Retford Circular Economy Project

Planning Statement Addendum

Figure 4.1 Conveyor and Maintenance road Alignment original/Amended Proposed Development.

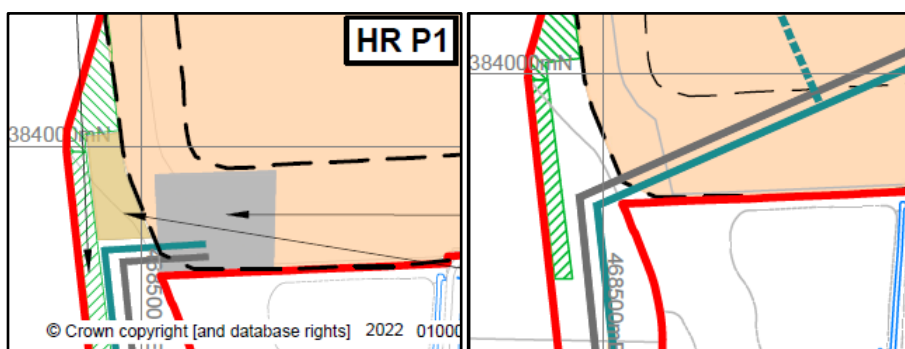
- 4.10 The maintenance road and conveyor are the principal elements of the Proposed Development within Area B. Both these elements remain mostly unchanged however at the border with Area A, the alignment and positioning of the maintenance road and conveyor would change.

- 4.11 Following the repositioning of the conveyor more centrally within the extraction area, further away from the SSSI and adoption of a progressive extraction methodology, the maintenance road and conveyor now travel at a 45 degree angle into HR P1. The updated alignment is shown on the updated Outline Site Layout Plan (Drawing ref. 403.000007.00001.12.002.P01). **Figure 4.1** also shows the change in the conveyor and maintenance road alignment, as it enters the Extraction Area in the original Scheme (left hand image) compared with the updated Scheme (right hand image).

- 4.12 In the original submission, extraction would begin on the border of Area B and A by digging into the southwest corner of the embankment of HR P1 in order to set up the first Temporary Processing area. Within the updated extraction methodology, extraction would begin by digging a cut to approximately 5m depth into the embankment in the southwest corner of HR P1 from which point the maintenance road and conveyor would extend into. As a result of this change the Amended Proposed Development no longer proposes a Soil and Overburden Store for HR P1 in the northern part of Area. This feature, shown as a yellow square in Figure 4.1), has been removed from the updated Outline Site Layout (Drawing ref. 403.000007.00001.12.002.P01) and Updated Phasing Plans (Drawing ref. 403.000007.00001.12.020-031.P01).
